Development Permit Panel

Wednesday, September 27, 2017
3:30 p.m.

1. **DEVELOPMENT PERMIT 16-726865**
(REDMS No. 5510231)

2. **DEVELOPMENT PERMIT 16-735007**
(REDMS No. 5493885)

Sheet Name
LANDSCAPE PLAN

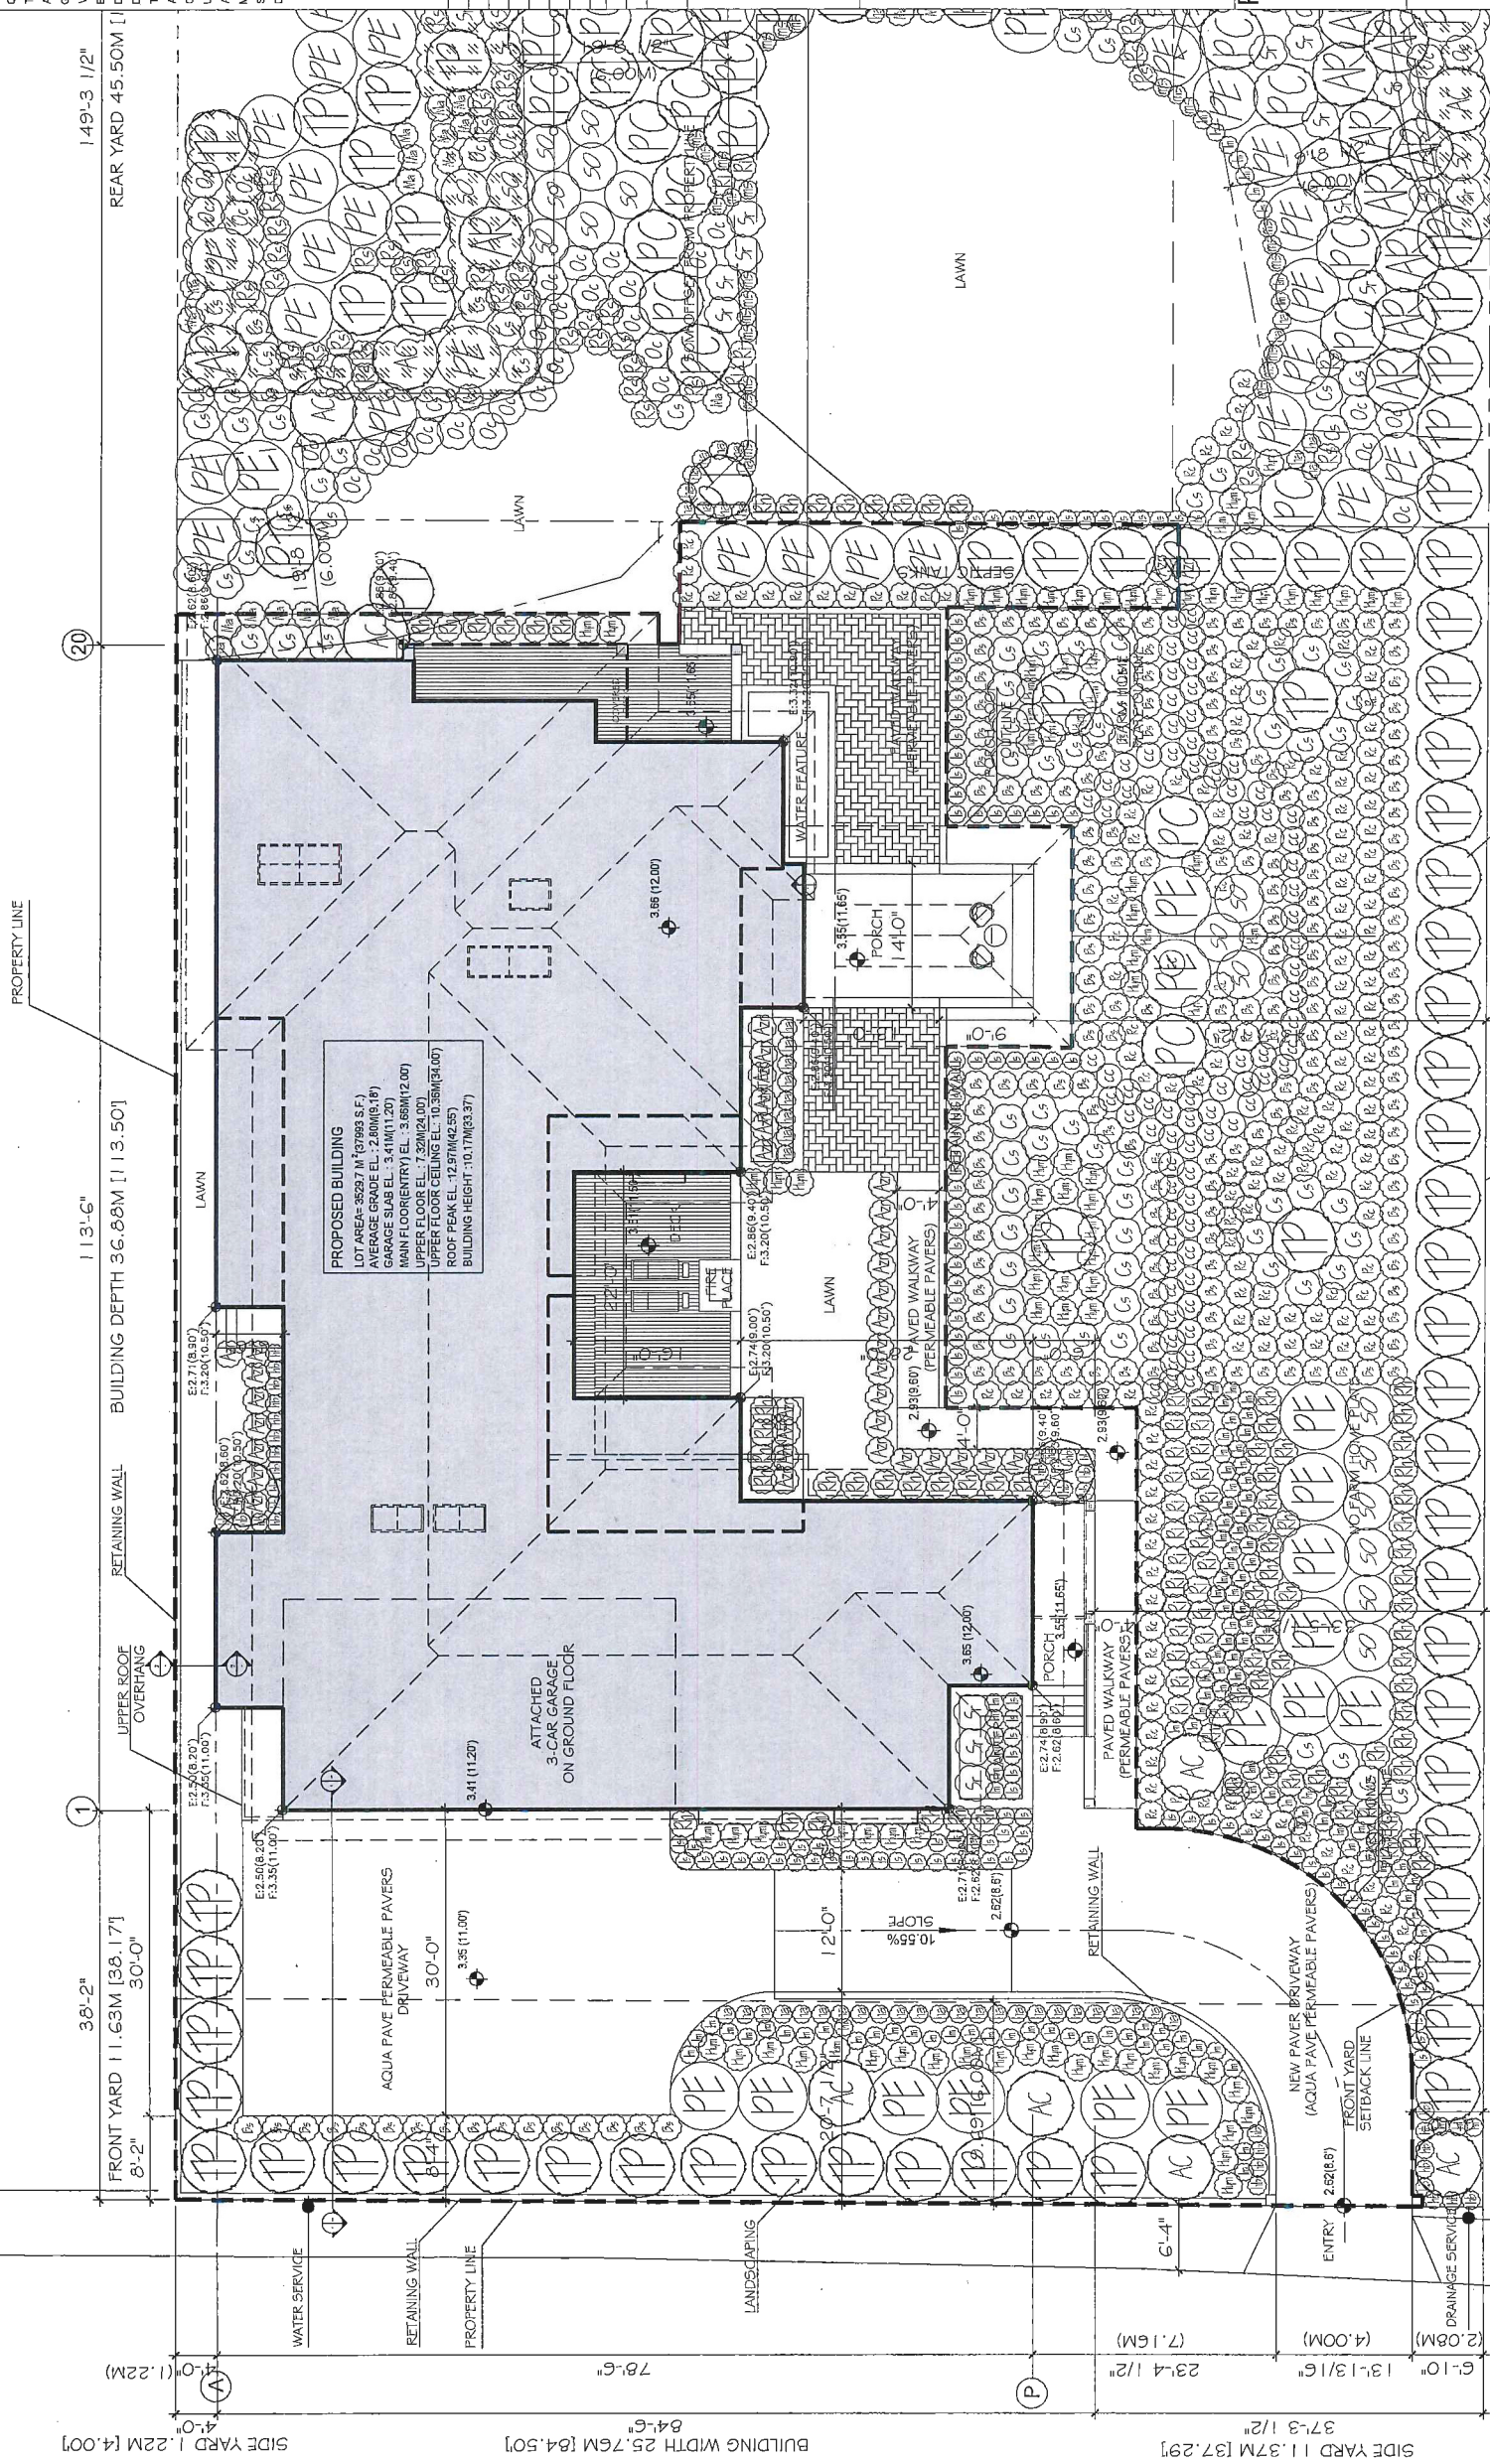
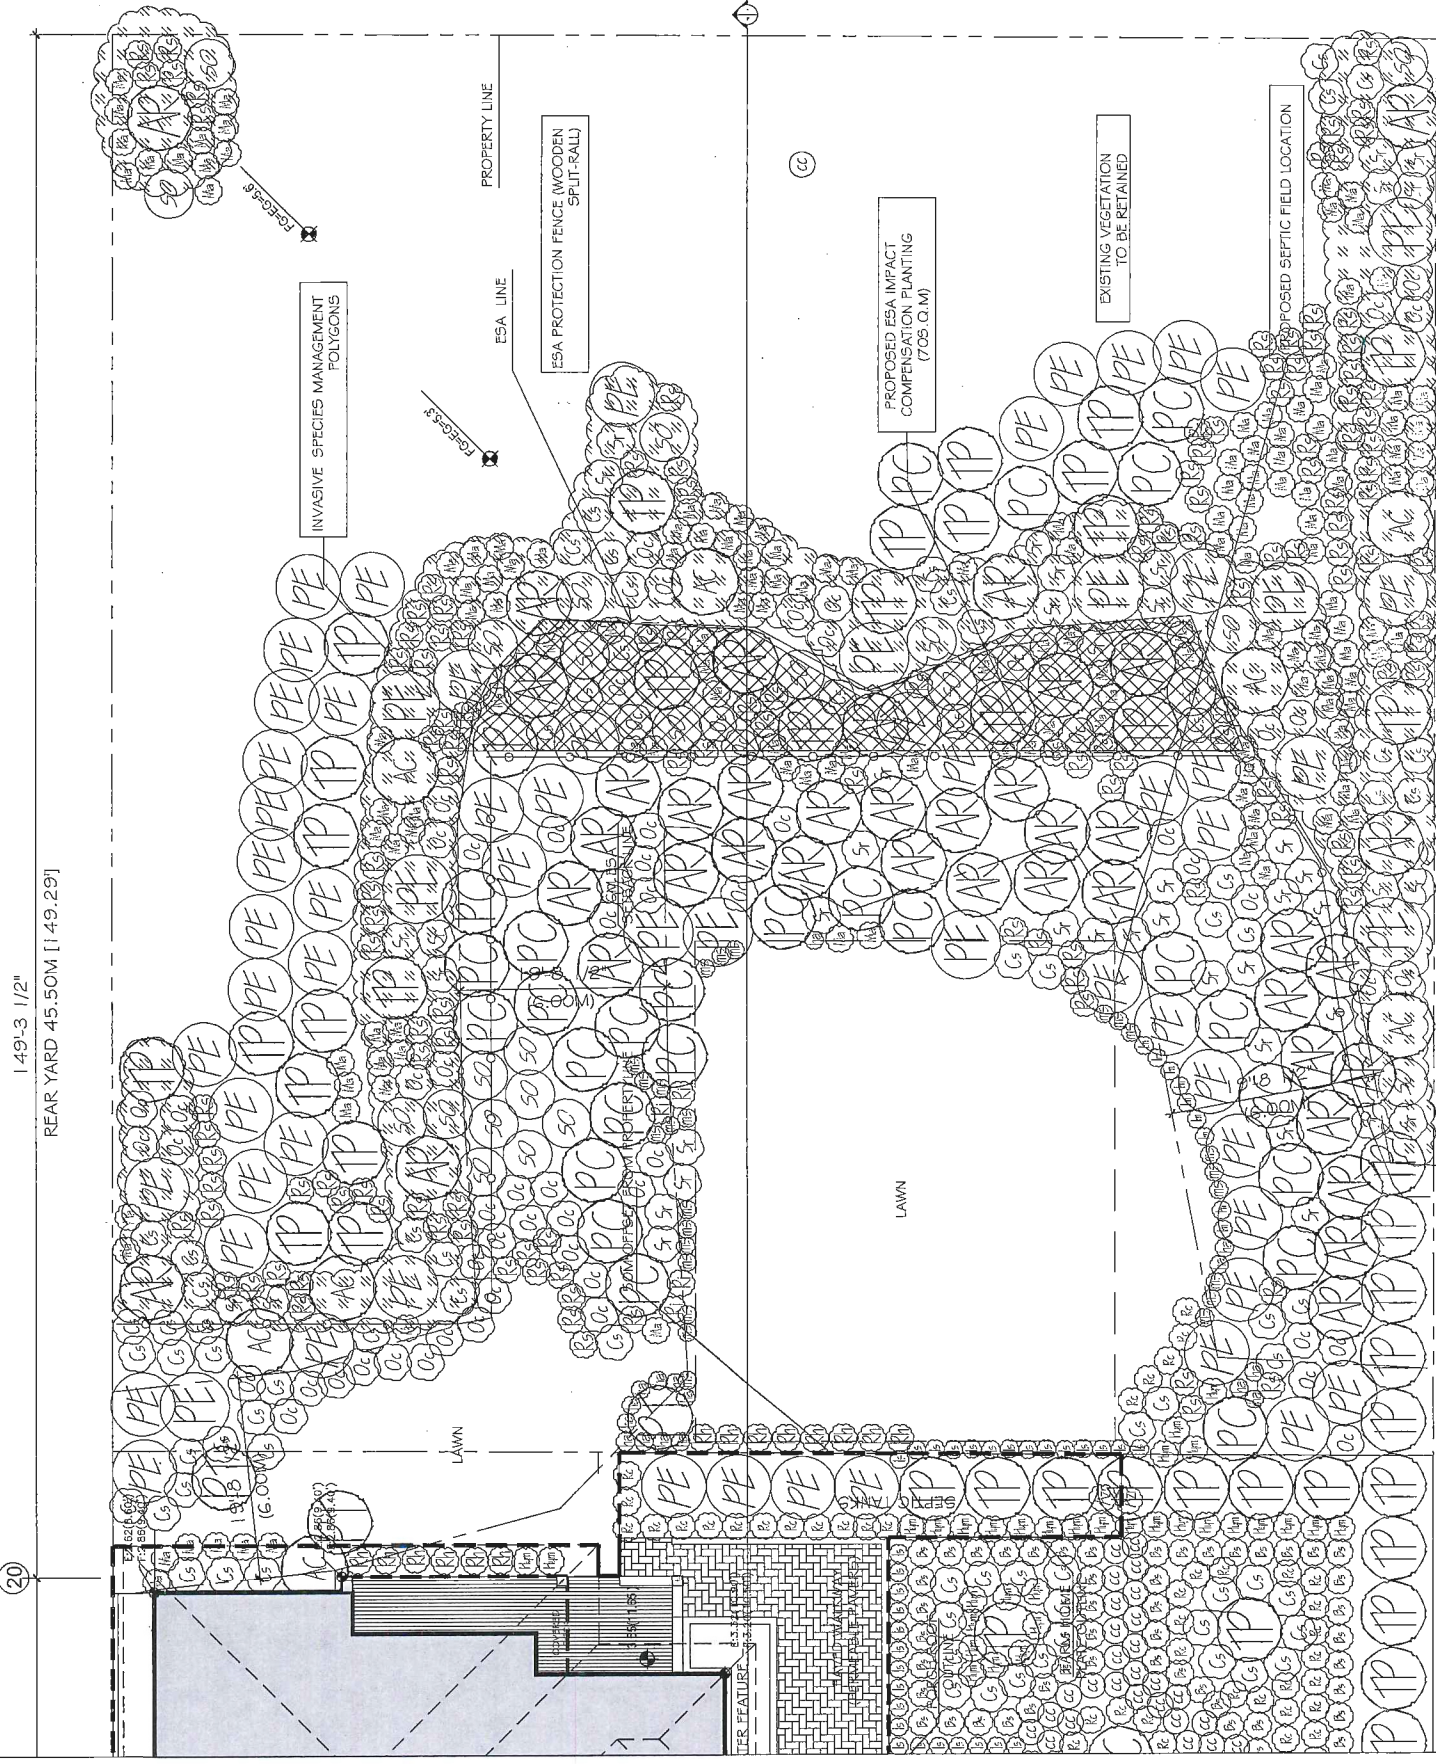
Panel Comment: *Further explain how the proposed landscaping would enhance the redefined ESA and mitigate the development's impacts to the ESA.*

Response: Three areas are proposed to be enhanced under the revised site plan:

- a. In and around the existing tree stand at the eastern end of the property, where invasive vegetation will be removed and replaced with native shrubs and trees.
- b. Across the area previously proposed for a driveway along the south side of the house, which is currently grassed with no trees and few native shrubs. The enhancement plan proposes a variety of native shrubs and trees to be installed; which will allow more opportunities for use by birds and small animals.
- c. Within part of the front yard setback adjacent to No. 4 Road.
Although this area is not included in the ESA calculations, it is proposed to be planted with a variety of native shrubs and trees replacing the largely grassed area at the front of the lot helping to increase the area of native planted landscaping.

The revised landscape plan will result in approximately 84 more trees and 356 more shrubs than the original submission overall. A total of 282 trees, 977 shrubs and 506 ground cover plants are proposed to be planted on site under the revised landscape plan.
